UNITED STATES PATENT AND TRADEMARK OFFICE

APPLICATION NO.	FILING DATE	FIRST NAMED INVENTOR	ATTORNEY DOCKET NO.	CONFIRMATION NO.
10/687,600	10/20/2003	Makoto Morishima	520.43227X00	2551
20457	7590	05/22/2006		
ANTONELLI, TERRY, STOUT & KRAUS, LLP 1300 NORTH SEVENTEENTH STREET SUITE 1800 ARLINGTON, VA 22209-3873				
			EXAMINER ALEJANDRO, RAYMOND	
			ART UNIT 1745	PAPER NUMBER

Office Action Summary

DETAILED ACTION

【図1】

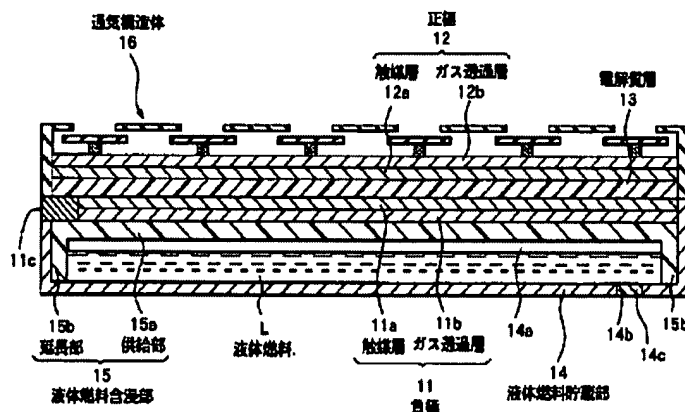
Figure 1 below of the JP'836 illustrates a power generating device including a negative electrode 11 to oxidize the fuel and a positive electrode 12 to reduce the oxygen and are providing opposing each other with an electrolyte layer interposed therebetween (ABSTRACT/

See Figure 1). As illustrated in Figure 1 below, the positive electrode 12 consists of two electrode plates 12a and 12b; and the negative electrode 11 consists of two electrode plates 11a and 11b. *It is noted that the plurality of both negative electrodes and positive electrodes satisfy the claimed requirement of having opposed anode and cathode electrodes in pairs with the solid polymer electrolyte interposed therebetween. Thus, the electrochemical cell has a plurality of both negative electrodes and positive electrodes.*

【図4】

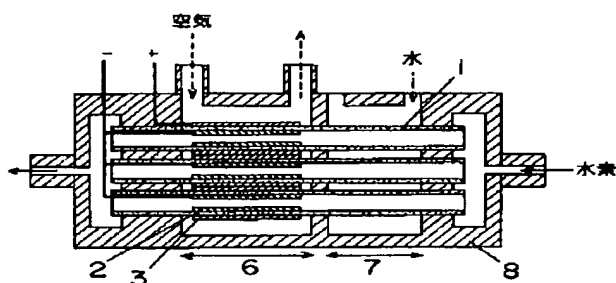
Figure 4 below of the JP'507 illustrates a solid polymer fuel cell including a plurality of negative electrodes 2, a plurality of positive electrodes and solid polymer electrolytes 1 (Abstract/ See Figure 4). Particularly, a negative electrode is disposed on an inside surface of a solid polymer electrolyte and a positive electrode is formed on an outside surface thereof

(Abstract/ See Figure 4). *It is noted that the plurality of both negative electrodes and positive electrodes satisfy the claimed requirement of having opposed anode and cathode electrodes in pairs with the solid polymer electrolyte interposed therebetween. It is further noted that the negative electrode performs the inherent function of oxidizing the fuel gas, and the positive electrode performs the inherent function of reducing the oxidant.*

Fig. 6

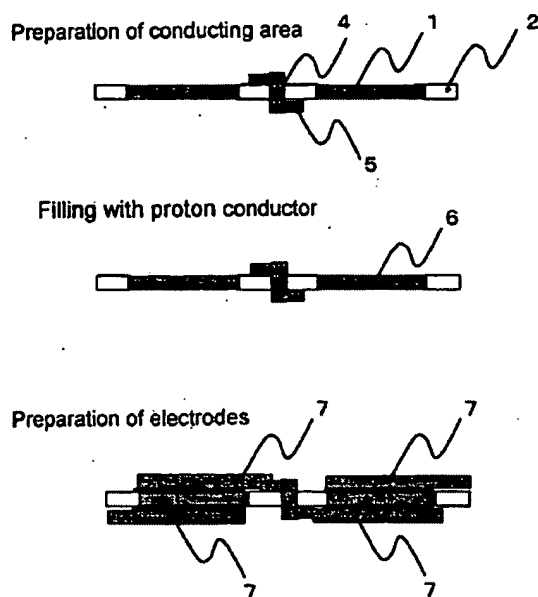
Figure 6 below of Kidai et al depicts a polymer electrolyte membrane comprising a plurality of electrodes 7 consisting of respective electrode substrates and electrocatalyst layers (P.0058). It is disclosed that connections occur between the anodes and the cathodes located in the opposite sides of the polymer electrolyte membrane, wherein it is preferably to have a structure which interposes electron conductor the polymer electrolyte membrane (P0011). Reference numeral 5 represents the electron conductor through membrane (*the wiring member*

which electrically connects adjoining electrodes); reference numerals 1 and 2 represent respective porous area and non-porous area of the polymer electrolyte membrane (P0025-0031).

Examiner's note: It is noted that the plurality of both negative electrodes and positive electrodes satisfy the claimed requirement of having opposed anode and cathode electrodes in pairs with the solid polymer electrolyte interposed therebetween. It is further noted that the negative electrode performs the inherent function of oxidizing the fuel gas, and the positive electrode performs the inherent function of reducing the oxidant.
